Date: **November 9, 1998**

Subject: **10% OVERSCANNING MODIFICATION**

Model: **BVM-20E1U, BVM-20F1U**

Figure 1

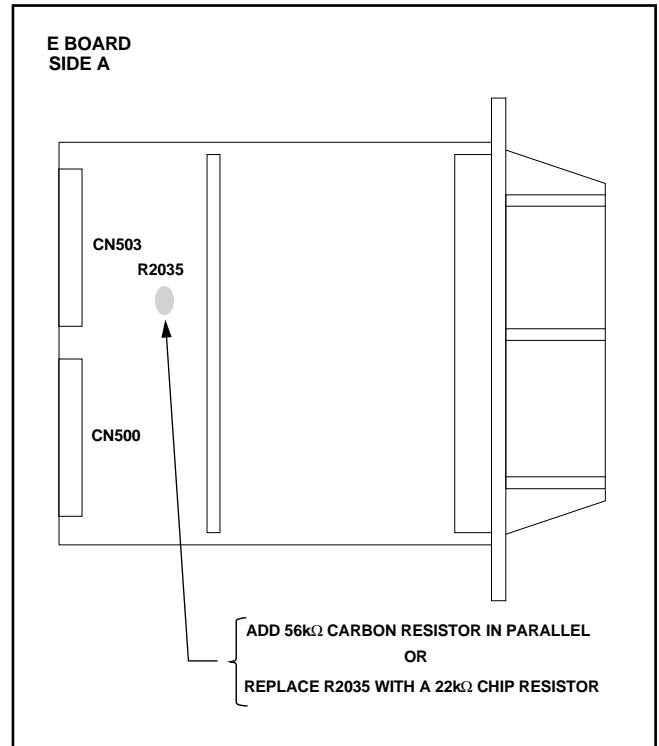
The specification for adjustable range of the scan size is $\pm 15\%$. However due to insufficient blanking, when signal is overscanned by more than 10%, horizontal fold-over may occur. This appears as faint shadows extending from the edge of the CRT screen.

Follow the procedure below to increase the amount of blanking.

1. Remove the E board.
2. Perform either step a or step b on side A:
 - a. Solder a 56k Ω carbon resistor in parallel with R2035 (33k Ω).
 - b. Replace R2035 with a 22k Ω chip resistor.
3. Reinstall the E board.
4. Turn power ON.
5. Input monoscope signal to adjust scan size.
6. Follow instructions in Operation and Maintenance Manual, 1st Edition, Rev. 1, Page 4-3, "H Blanking Adjustment" section to adjust H SIZE, H BLK PHASE, H CENTER, H PHASE and H BLK WIDTH for 4:3 NORMAL, 4:3 UNDER, 16:9 NORMAL, and 16:9 UNDER.
